Sewage System Evaluation Certificate of Review

Address: 6323 MIDDLEBRANCH AVE NE
City: CANTON Zip: 44721
Company: Skelley Septic Services LLC
Inspection Date: 08/01/2026
Initial Review Date: 08/06/2026

Parcel ID: 5202897
Township: PLAIN TOWNSHIP
Inspector: Ben Skelley
Review #: 13964
Initial Review by: Chris Novelli

Property Evaluation Diagram

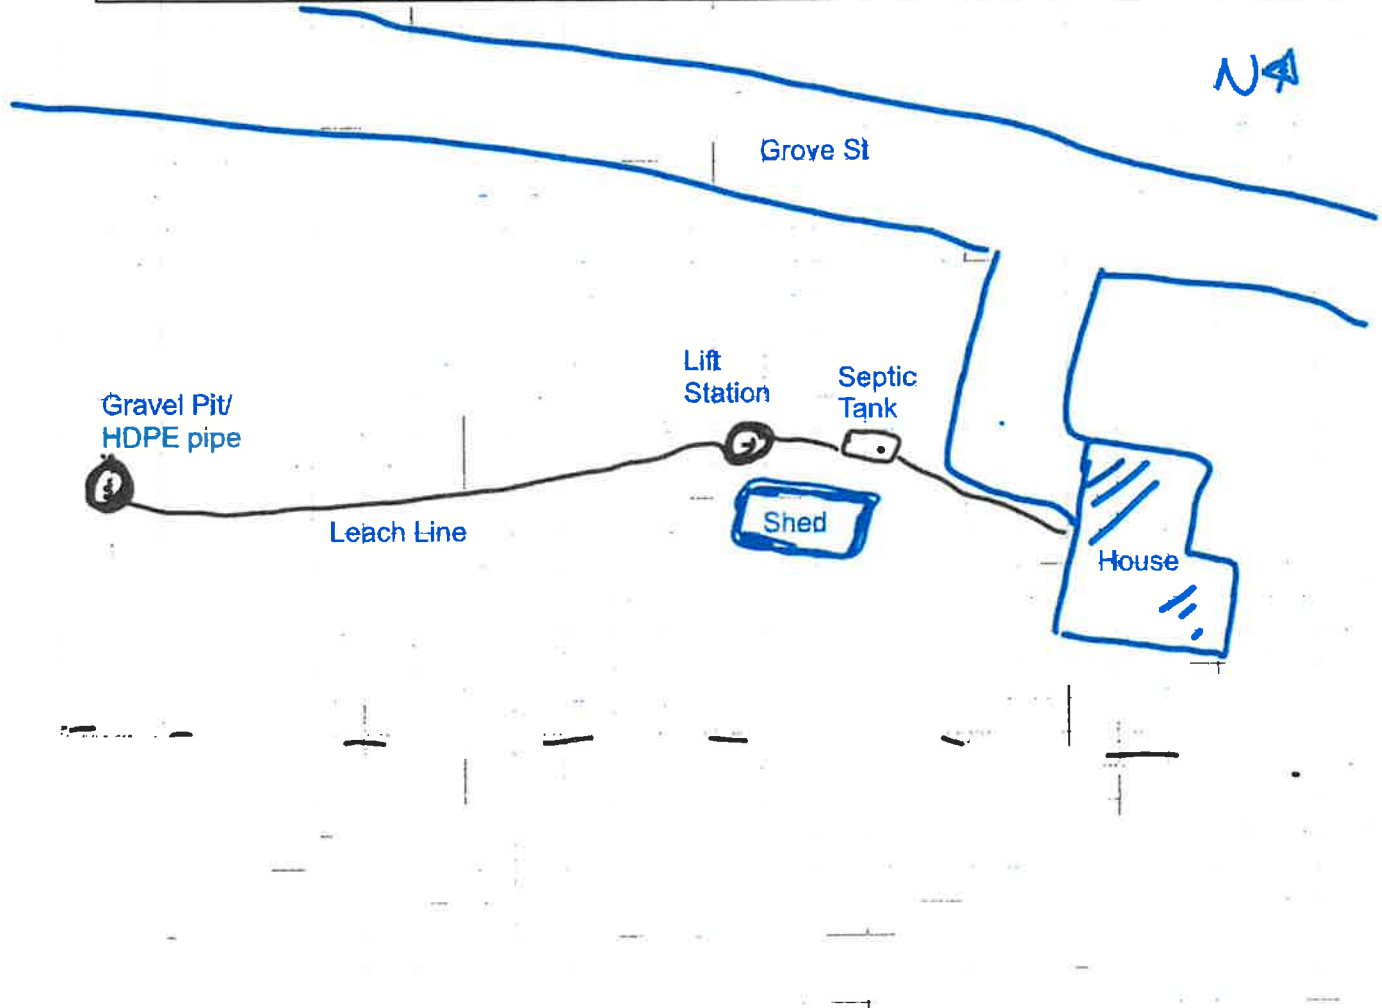
COMMENTS CONCERNING SYSTEM: No records on file for the septic. Per seller, there is a septic tank, lift station, 1 long 100+ foot leach line, that then has an overflow into a gravel pit. On site, there was access to the inlet of the tank,

and the lift station, as well as the above mentioned gravel pit. This is a 15 in HDPE pipe stood on end with gravel at the very bottom, and per seller, gravel around the outside of it. The overflow pipe from the leach line enters the side wall of the HDPE pipe at about 5 feet deep, and the bottom, where the gravel is, is at 10 feet deep.

During the load test, flow was constant through the tank and the lift station cycled. No flow was ever observed in the HDPE pipe/gravel pit, so it appears the leach line is currently leaching.
